EL18-026 - IN THE MATTER OF THE
APPLICATION BY PREVAILING
WIND PARK, LLC FOR A PERMIT OF
A WIND ENERGY FACILITY IN BON
HOMME COUNTY, CHARLES MIX
COUNTY AND HUTCHINSON
COUNTY, SOUTH DAKOTA, FOR THE
PREVAILING WIND PARK PROJECT

APPLICANT'S RESPONSES TO
STAFF'S FIFTH SET OF DATA
REQUESTS
EL18-026

Figure D-1
 Prevailing Wind Park
 Sound Level Contours

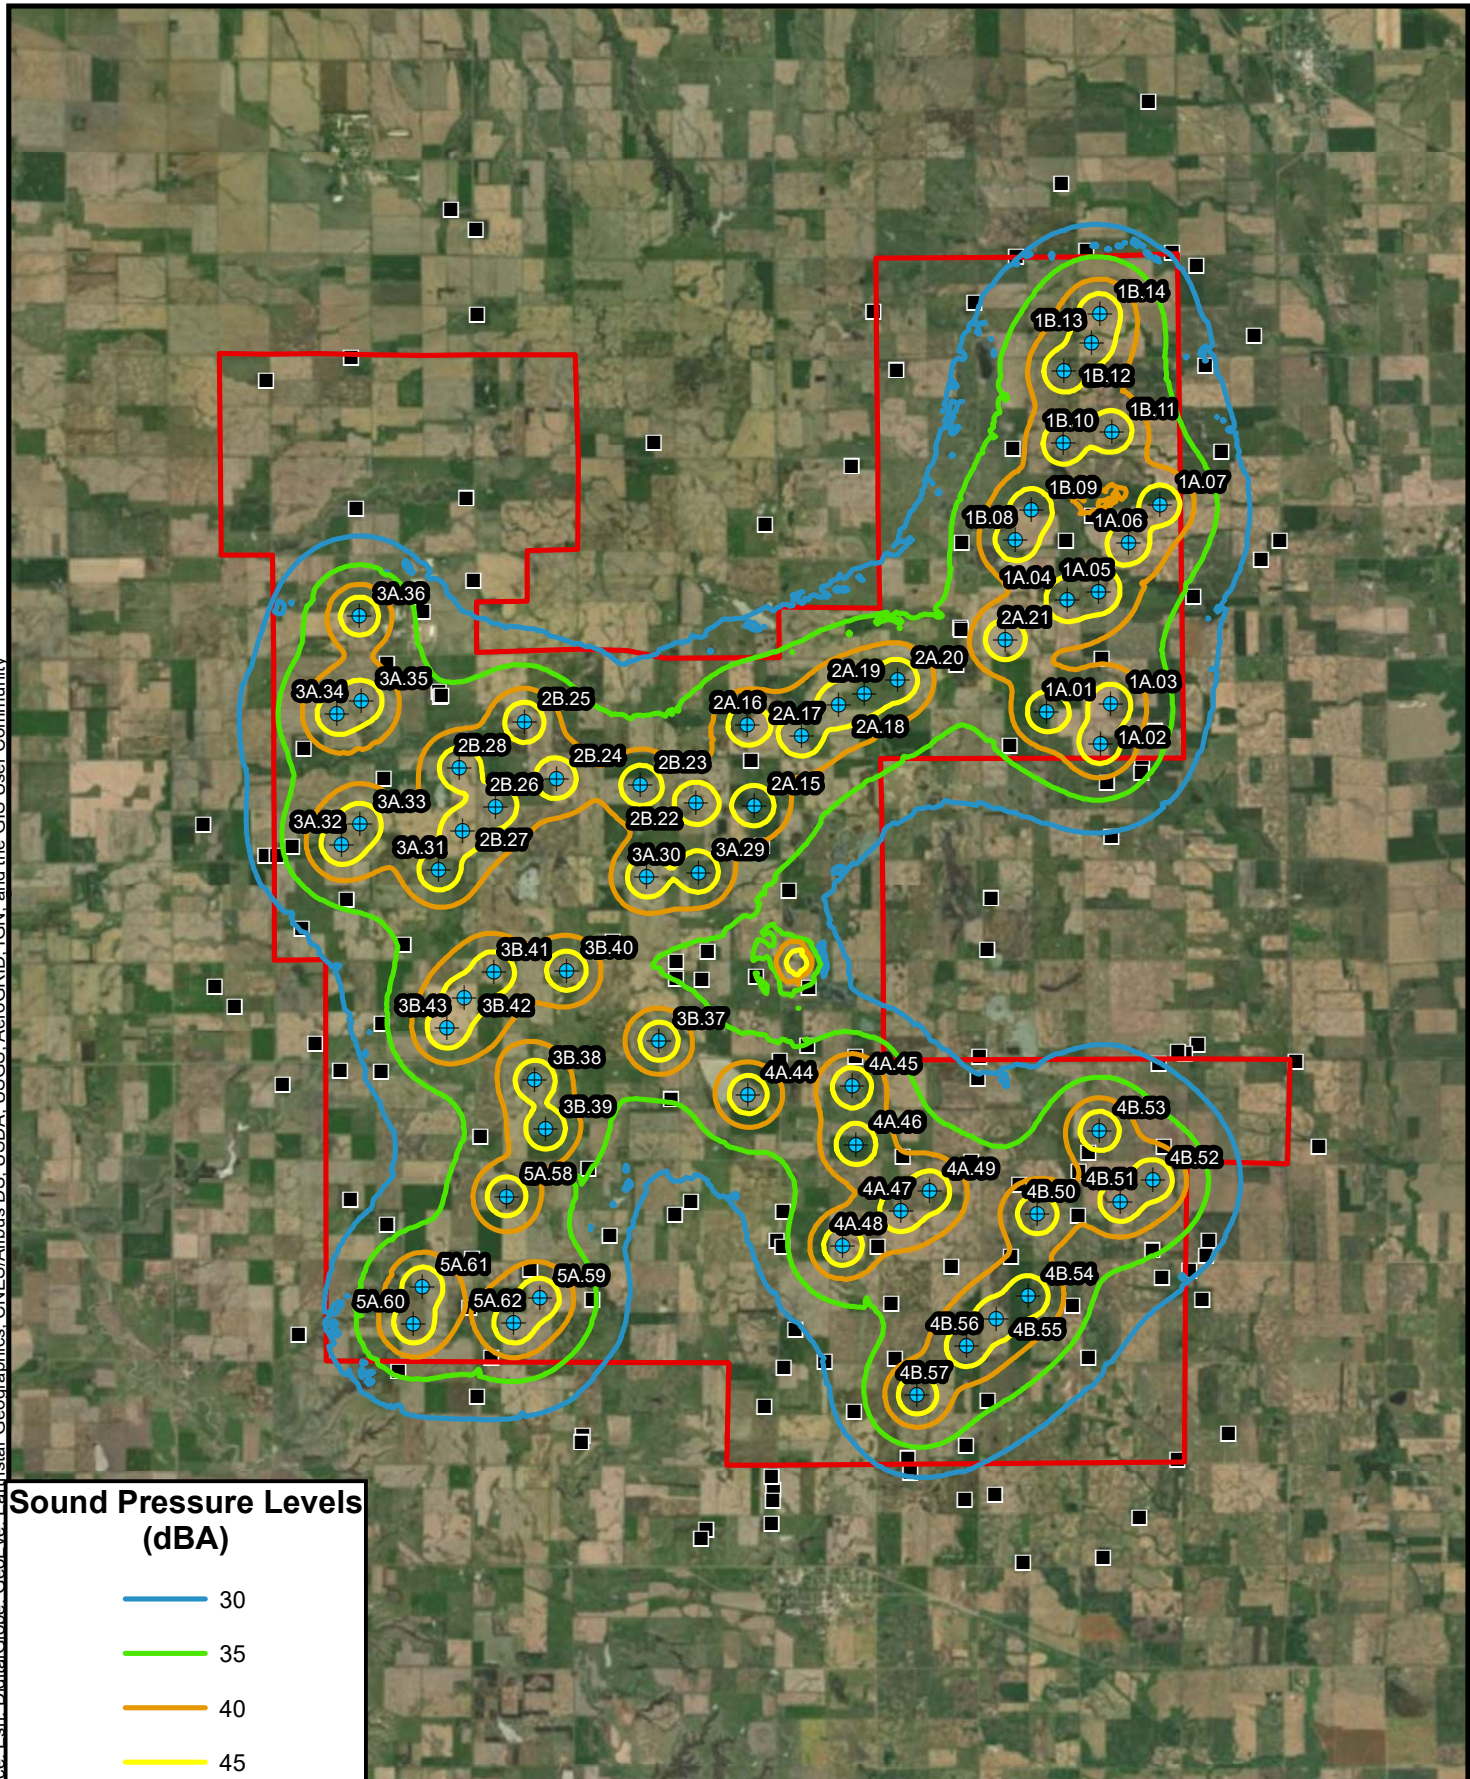
- b) Please submit a map that shows the contour lines for 30, 35, and 40 dBA using the sound model results that the Applicant believes accurately reflects predictive sound levels.

Chris Howell: See Attachment 5-4
